**Pacific Gas and
Electric Company**

PG&E Letter DCL-01-115

Docket No. 50-275, OL-DPR-80
Docket No. 50-323, OL-DPR-82
Diablo Canyon Units 1 and 2
License Amendment Request 01-05

Revision to Technical Specification 1.1, "Definitions, Dose Equivalent I-131," and
Revised Steam Generator Tube Rupture and Main Steam Line Break Analyses

Figure 15.4.3-1 Pressurizer Level

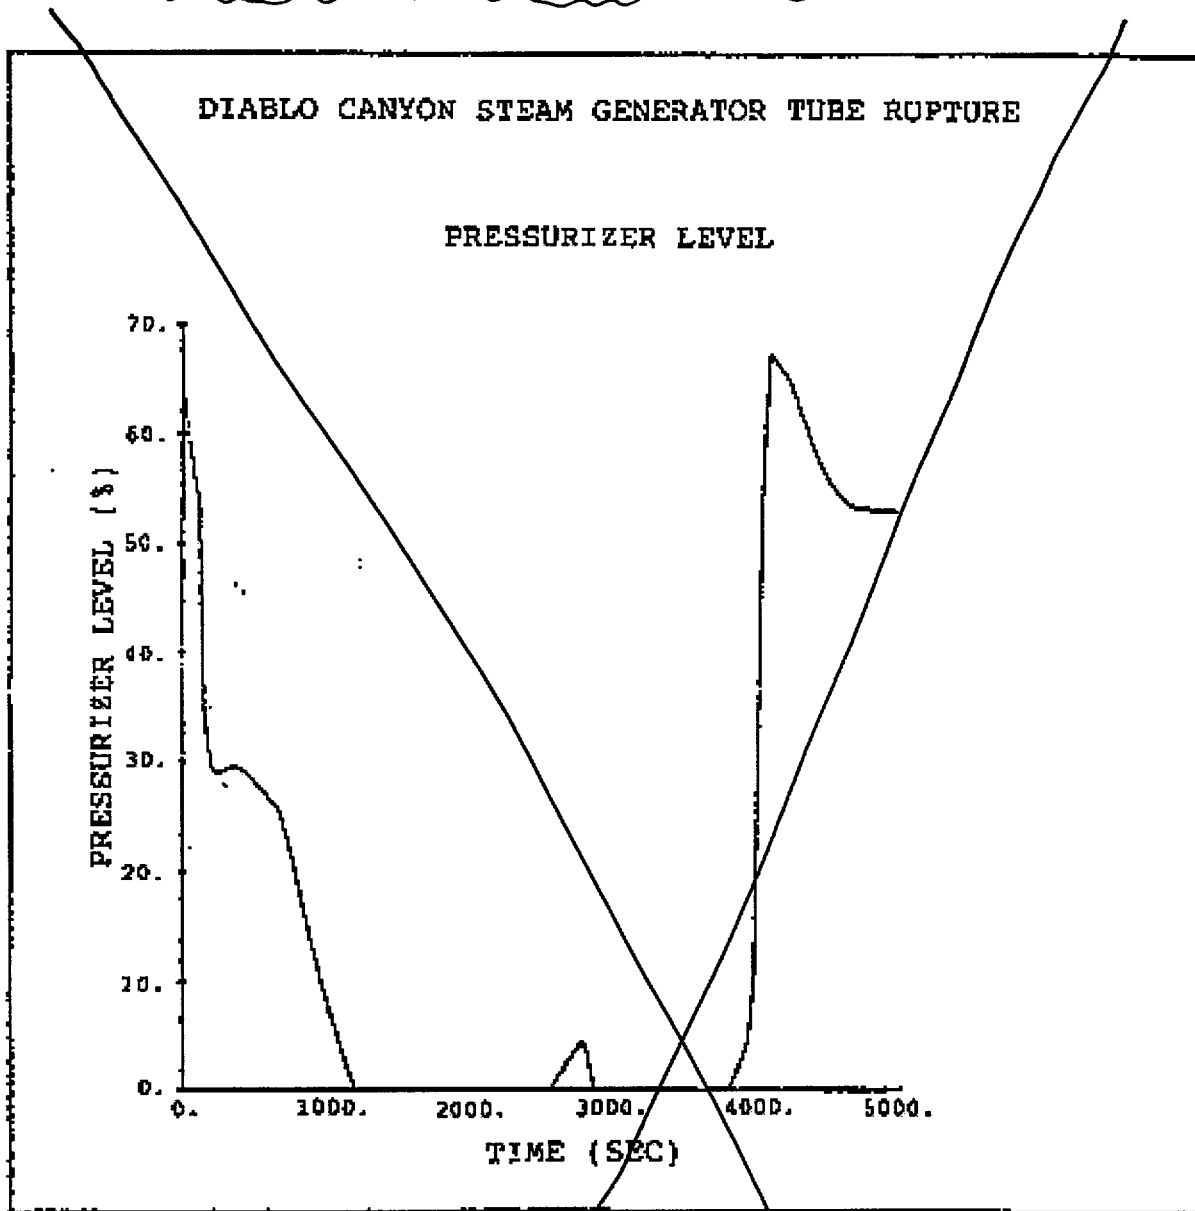
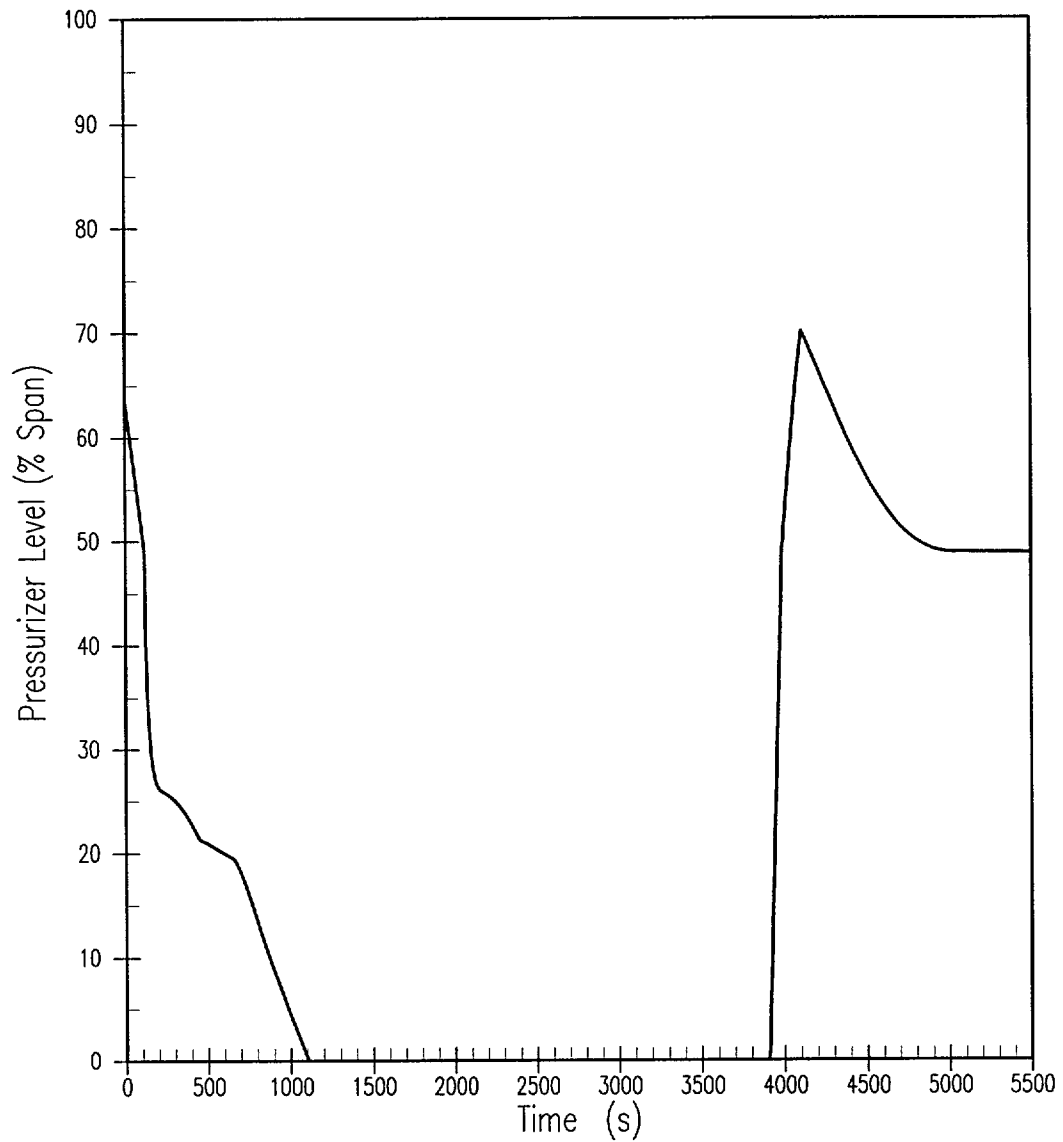
Replace with Figure 15.4.3-1

Figure 15.4.3-2 Pressurizer Pressure

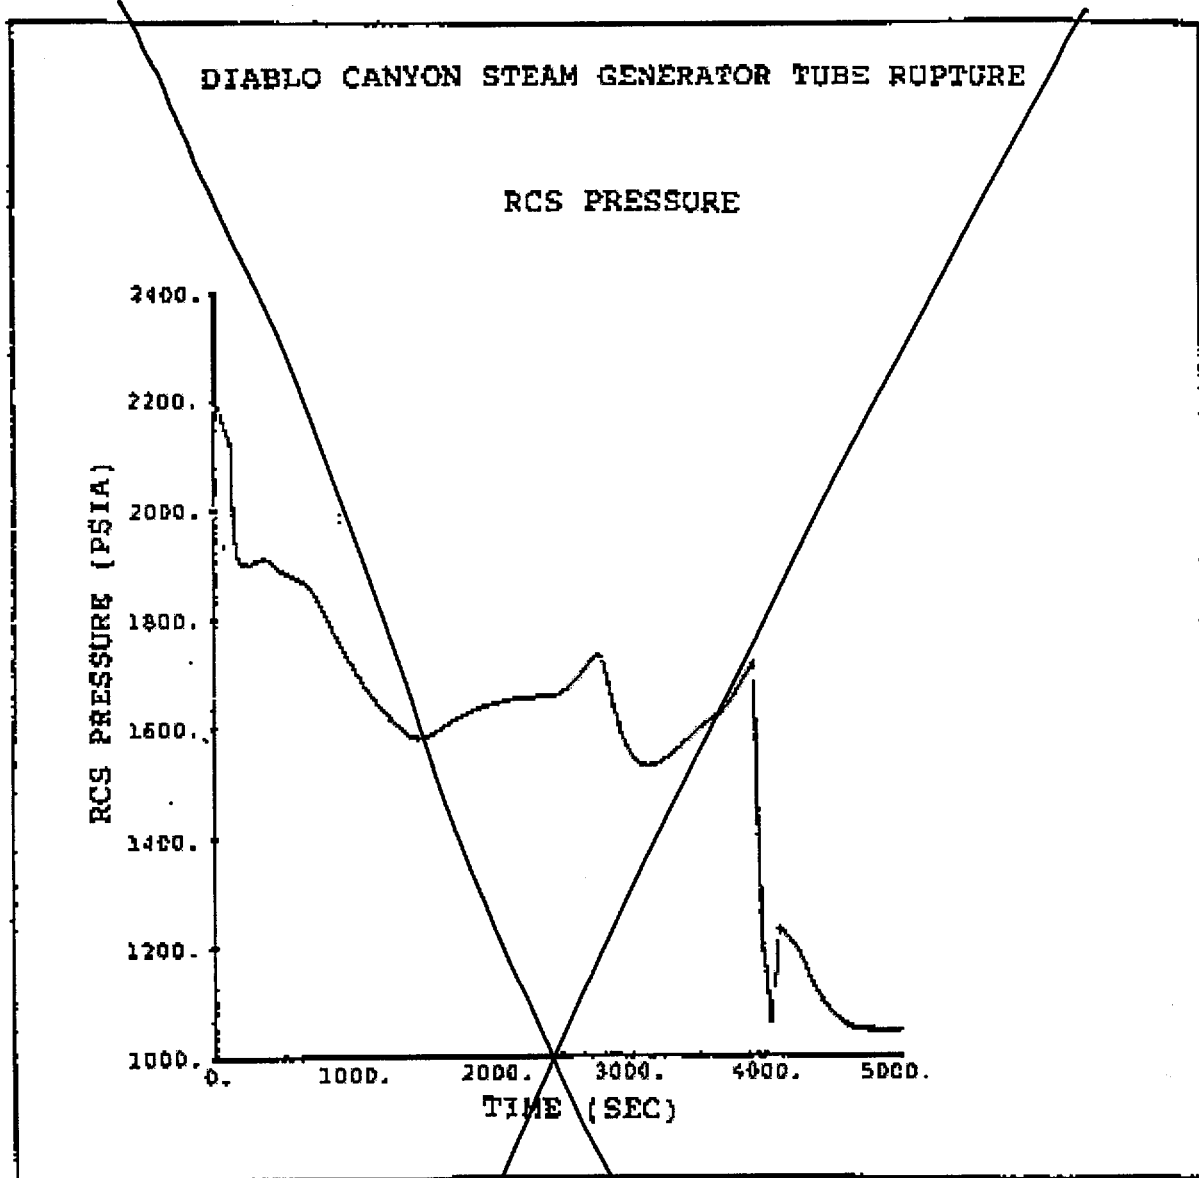
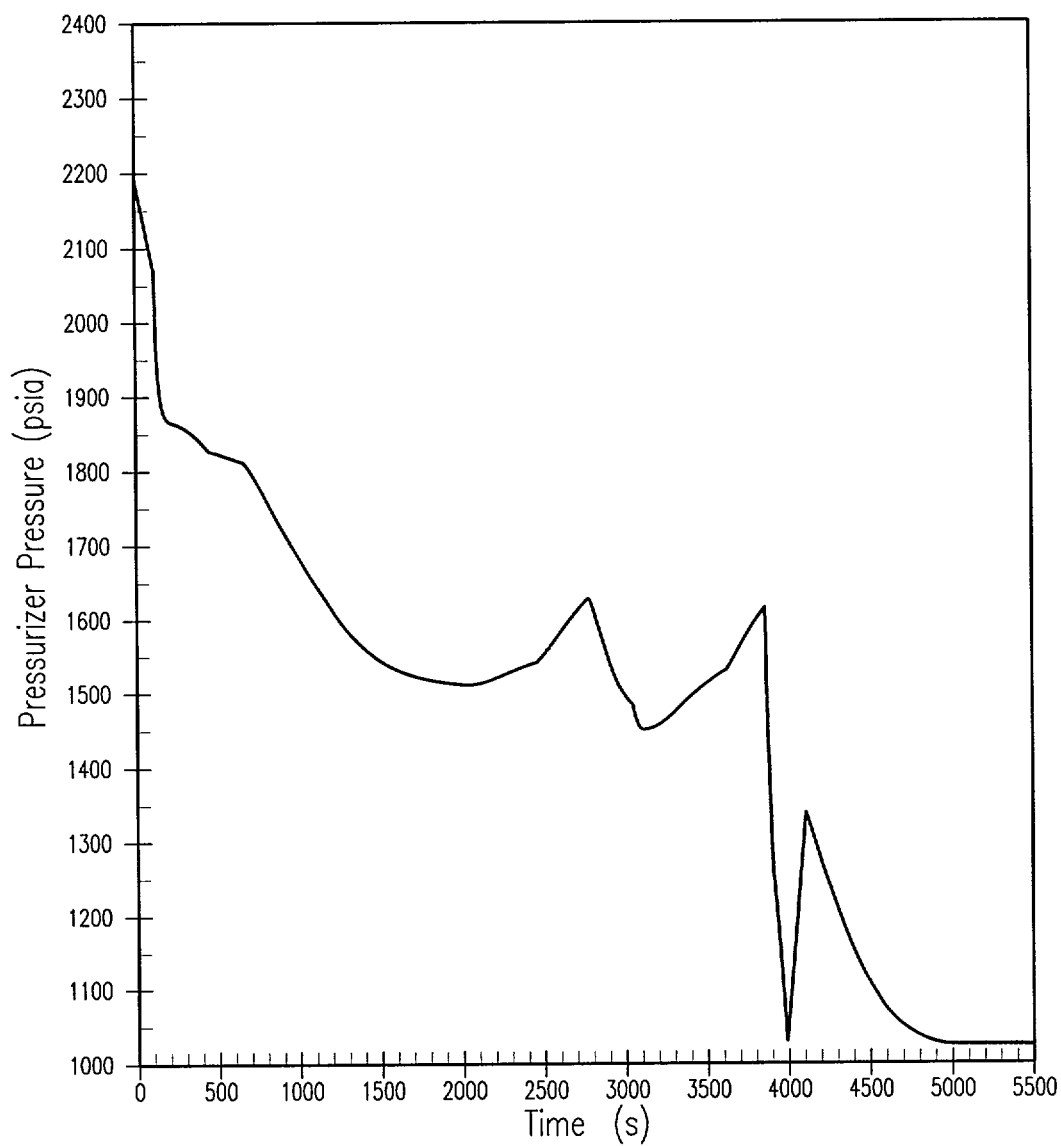
Replace with Figure 15.4.3-2

Figure 15.4.3-3 Secondary Pressure

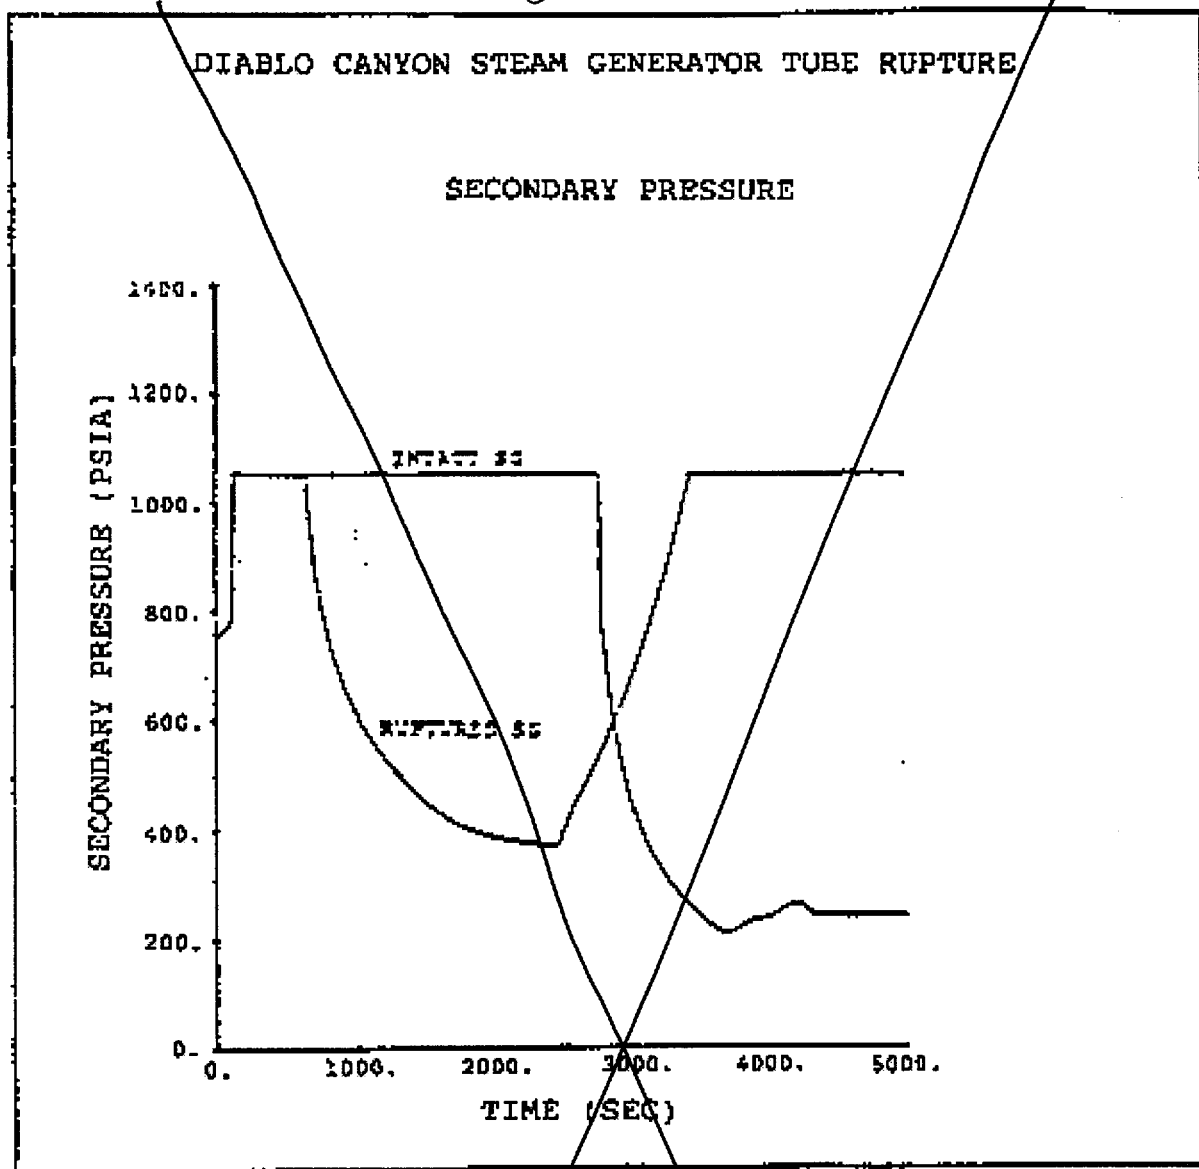
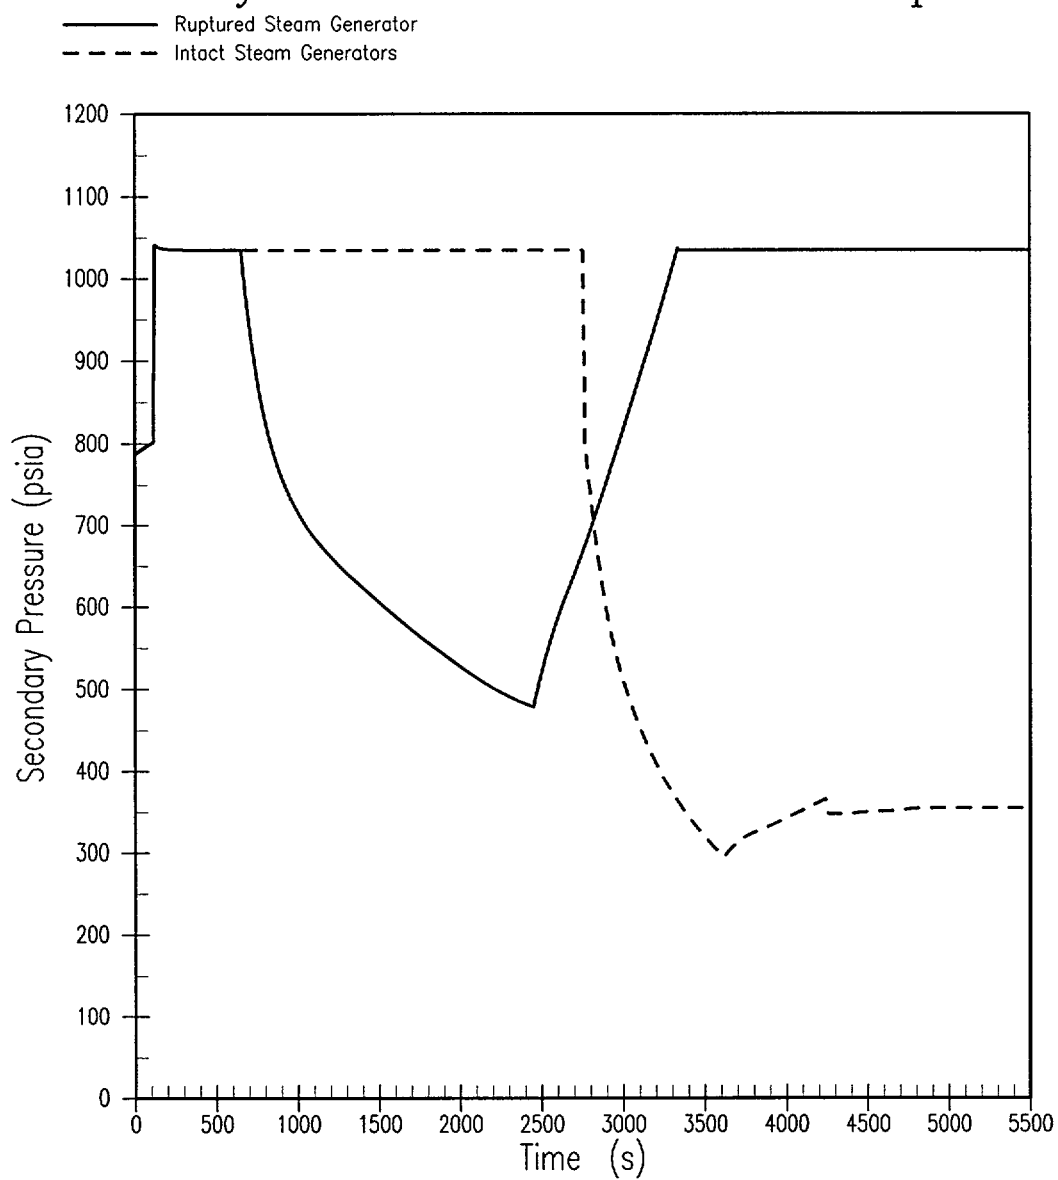
Replace with Figure 15.4.3-3

Figure 15.4.3-4 Intact Loop Hot and Cold Leg RCS Temperature

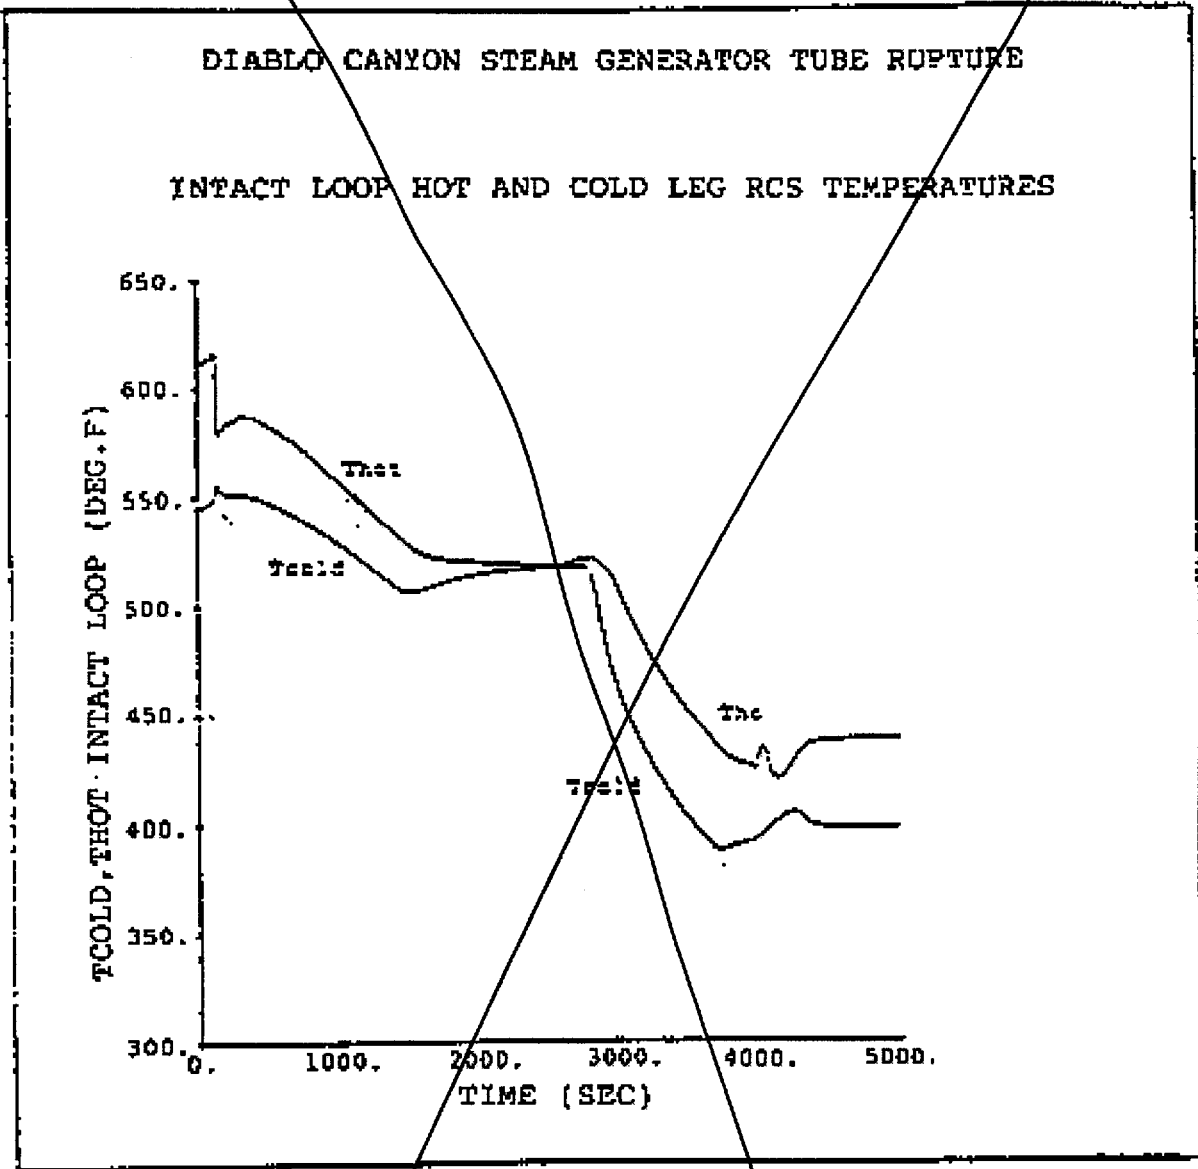
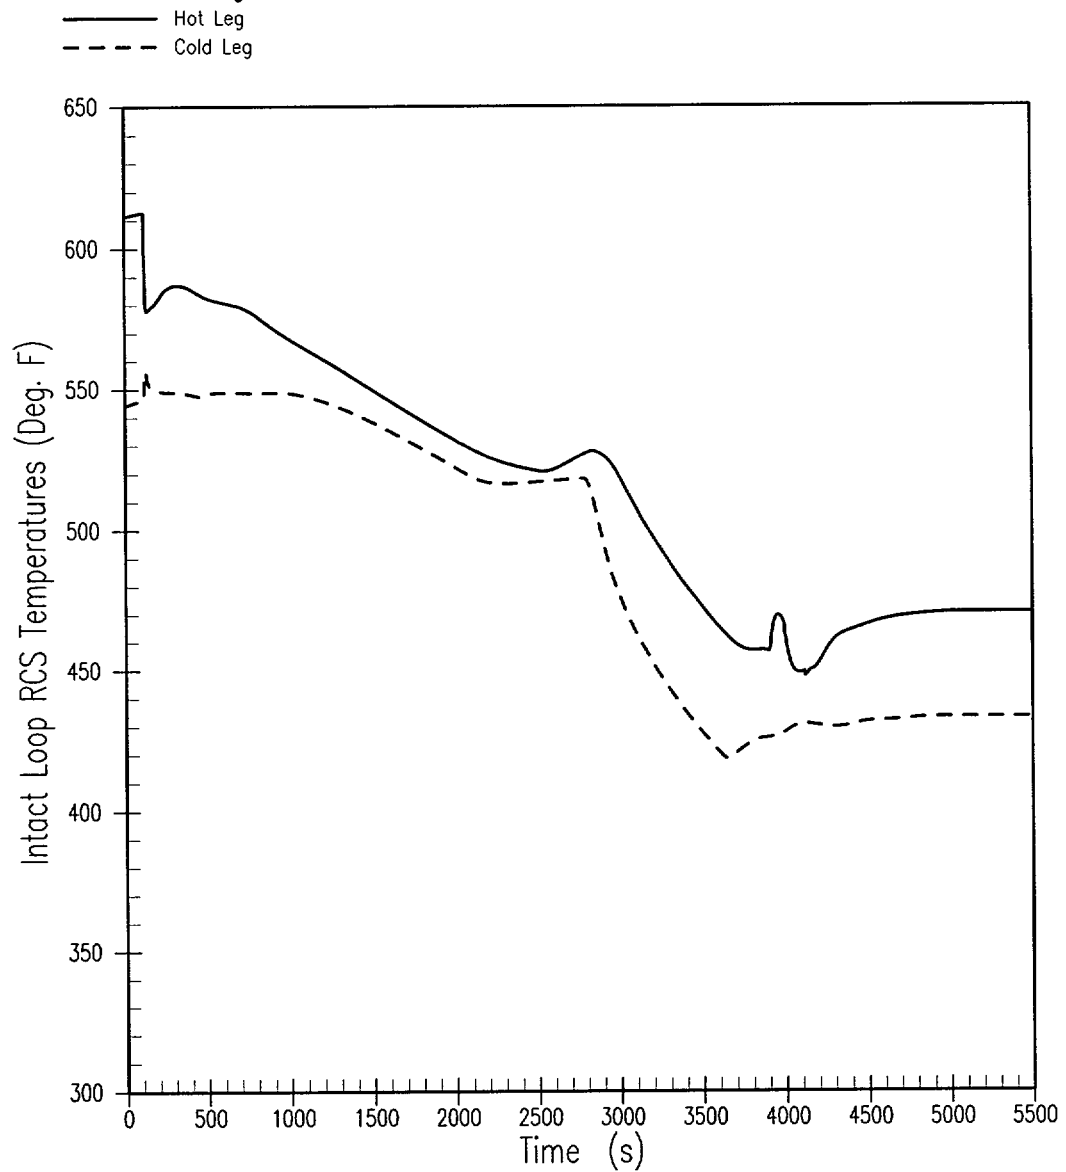
Replace with Figure 15.4.3-4
